ADDENDUM NO. 2

DATE: June 27, 2016

Contract 15-C-00021; Howard F. Curren AWTP HPO Gearbox/Mixer Upgrades and Piping Replacement

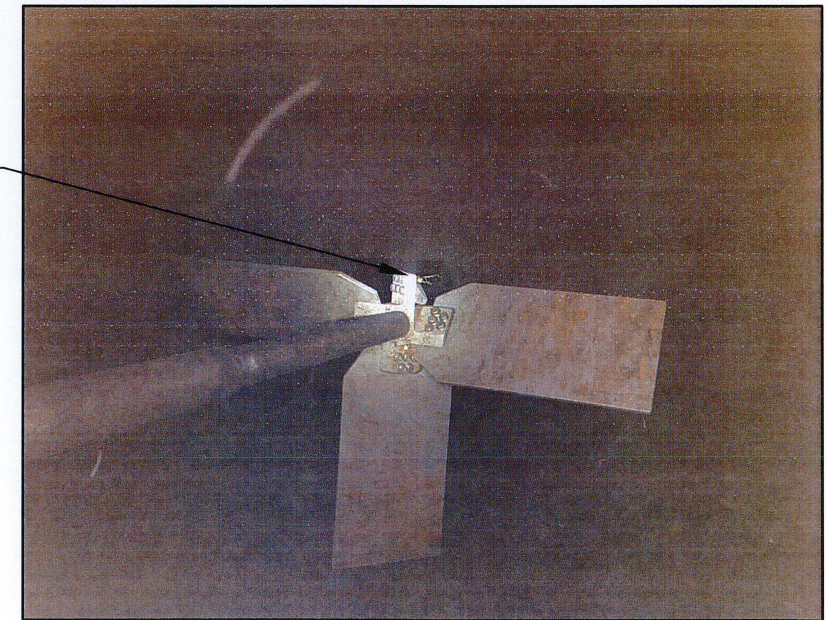
Item 2: Replace plan sheet 7 with the attached plan sheet 7.

- 1 THE MIXER DRIVE GEARBOX SHALL BE DESIGNED TO MOUNT ON THE EXISTING I-BEAM BASE STRUCTURE WITHOUT MODIFICATIONS TO THE I-BEAM STRUCTURE. MODIFICATIONS OF THE EXISTING I-BEAM STRUCTURE SHALL NOT BE ALLOWED. HOWEVER, DRILLING OF NEW MOUNTING HOLES IN THE I-BEAM STRUCTURE TO ACCEPT THE NEW MIXER DRIVE WILL BE ALLOWED IF THEY DO NOT COMPROMISE STRUCTURAL INTEGRITY.
- 2 PAINT EXISTING W12 x 72 BEAMS (2), HOLD DOWN CLIPS AND NEW STEEL PLATE. (SEE SPECS)
- 3 CONNECT NEW MOTOR TO EXISTING ELECTRICAL CONDUIT.
- 4 INSTALL AIR TIGHT SEAL GASKET BETWEEN PROPOSED STEEL PLATE AND CONCRETE.
- 5 REUSE EXISTING HOLD DOWN CLIPS
- 6 PROPOSED INSPECTION HATCH

- 7 CONTRACTOR SHALL INSTALL NEW IMPELLER BLADES AND HUBS IF EXISTING BLADES AND HUBS ARE MISSING OR DAMAGED. THE CITY WILL FURNISH THE NEW IMPELLER BLADES AND HUBS FOR INSTALLATION. CONTRACTOR SHALL PROVIDE ALL STAINLESS STEEL HARDWARE TO MATCH EXISTING. EXACT QUANTITY OF BLADES TO BE REPLACED IS UNKNOWN BUT SHOULD NOT EXCEED A TOTAL OF 5 IMPELLER BLADES.
